Reference: Response to Planning Board Comments

Site Plan Review Application

Rocky Maple Solar Off North Carver Road

B+T Project No. 3203.00

Photograph 1: Bog planting using sand and individual cranberry vine "plug" methodology.

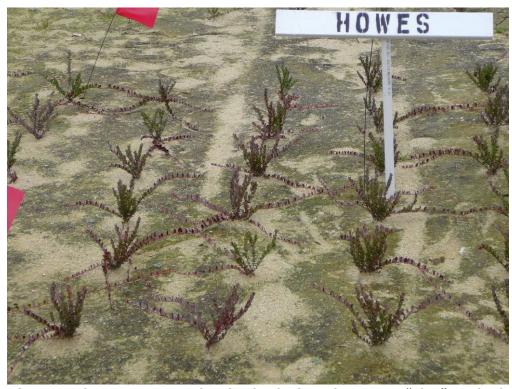
2. The concern over land restoration in this case would rest more with the landowner and would not have a significant impact on erosion in the same way as upland solar projects might have. But the damage to the cranberry bogs during the removal process could be significant. It should be made clear that the approval of such a project as this by the Wareham Planning Board does not imply liability for bog damage that might occur.

Response: To restore areas of damage due to repairs or construction on the bogs, typically, growers simply add sand from onsite resources or stockpiles and either plant small plugs or distribute cuttings from nearby vines over disturbed or bare areas, similarly to the photographs below.

The plugs are planted directly into the substrate by hand or tractor pulled planting mechanism in large areas.

January 23, 2021: Traveling northbound on Route 58

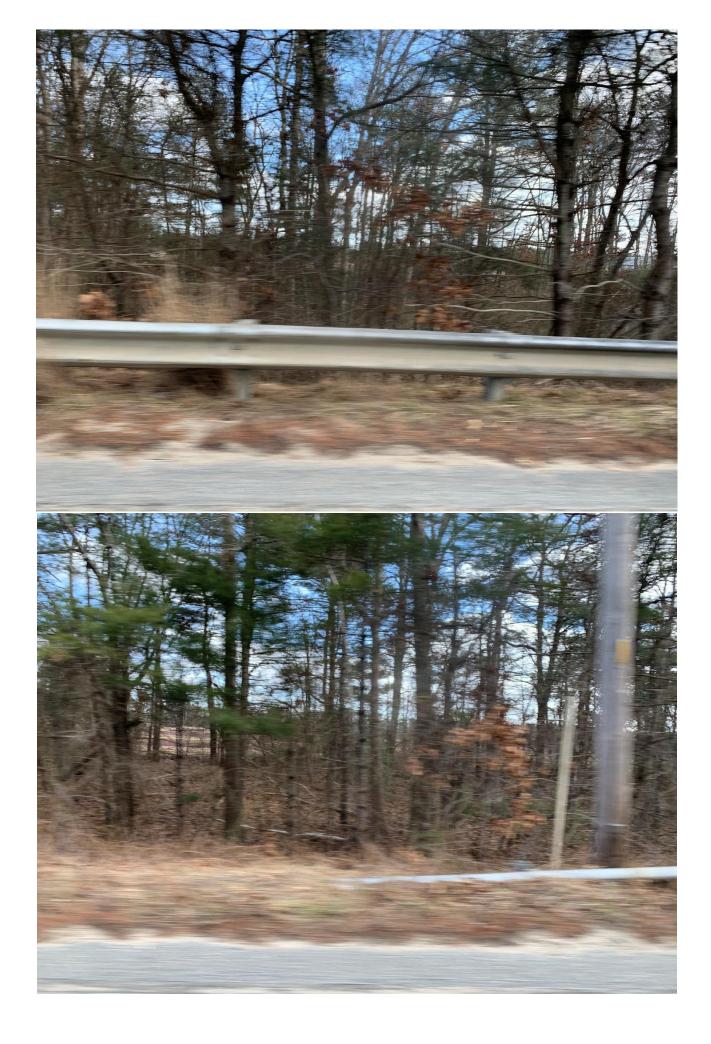
5. Section 594.3(1) requires structures to screened from view from outside the project site, from the public right of way and from residential districts. In this instance it would apply to all of the battery storage areas that are part of the project.

Response: The Project generally abuts lands in similar nature including cultivated cranberry bogs to the south and west. The Project abuts North Carver Road to the west and is naturally screened along this side as discussed at the Planning Board hearing on February 22, 2021. Refer to the enclosed photographs taken while driving along Route 58 depicting the existing vegetation. The Applicant has been in contact with the direct residential abutter and has provided a letter of support herein.
